# **APPENDIX D: NOTICES OF MODIFICATION**

# **Notice of Modification**

The project approval (08 0101) granted by the Minister for Planning on 26 November 2010 for the Integra Underground Project.

The development consent (SSD 5850) for the Mount Owen Continuation Project, granted by the Planning Assessment Commission, as delegate of the Minister for Planning on 3 November 2016.

Figure 3: Water Pipeline Infrastructure

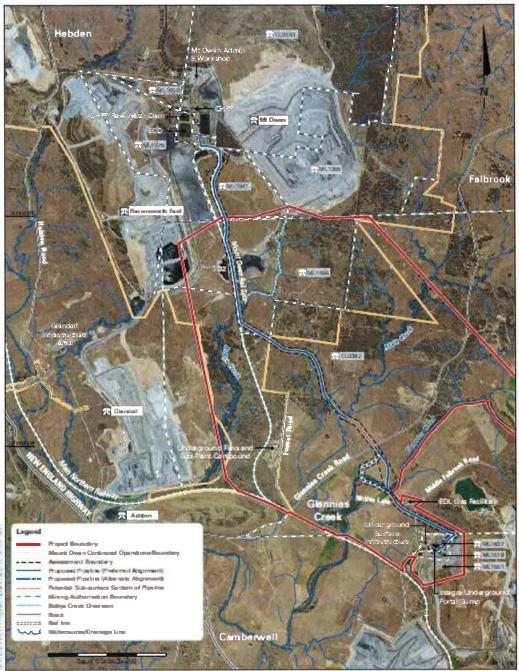
- 24. In Appendix 3:
  - (a) delete the title "Hebden and Barrett Mine Seam Areas" and replace with "Figure 1: Hebden and Barrett Mine Seam Areas";
  - (b) delete the title "Middle Lidell Seam Areas" and replace with "Figure 2: Middle Liddell Seam Areas"; and

- (c) insert the following figure:

Figure 2D(i): Development Layout – Water pipeline from Integra Underground to Mount Owen Complex

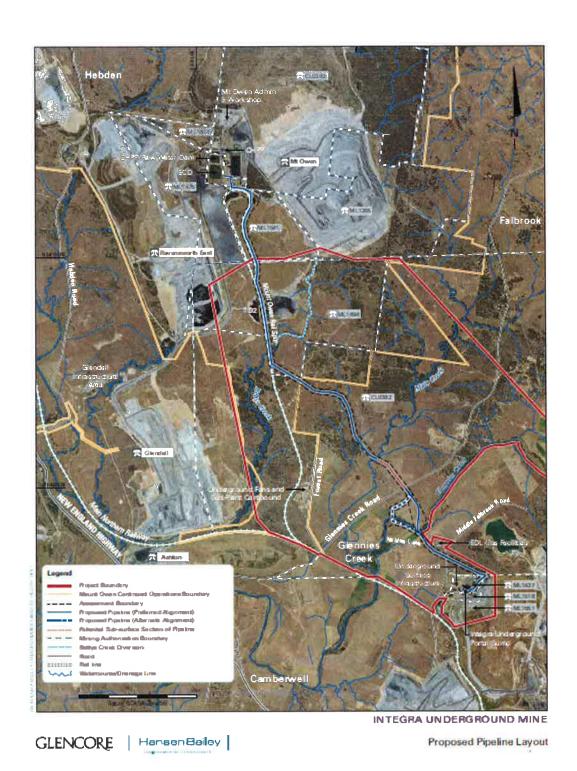
- 6. In condition 8 of Schedule 5, delete the words "Guidelines for Establishing and Operating Community Consultative Committees for Mining Projects (Department of Planning, 2007 or its latest version or replacement)" and insert "Department's Community Consultative Committee Guidelines State Significant Projects November 2016, or its latest version".
- 7. In Appendix 2, after Figure 2D, insert the following:
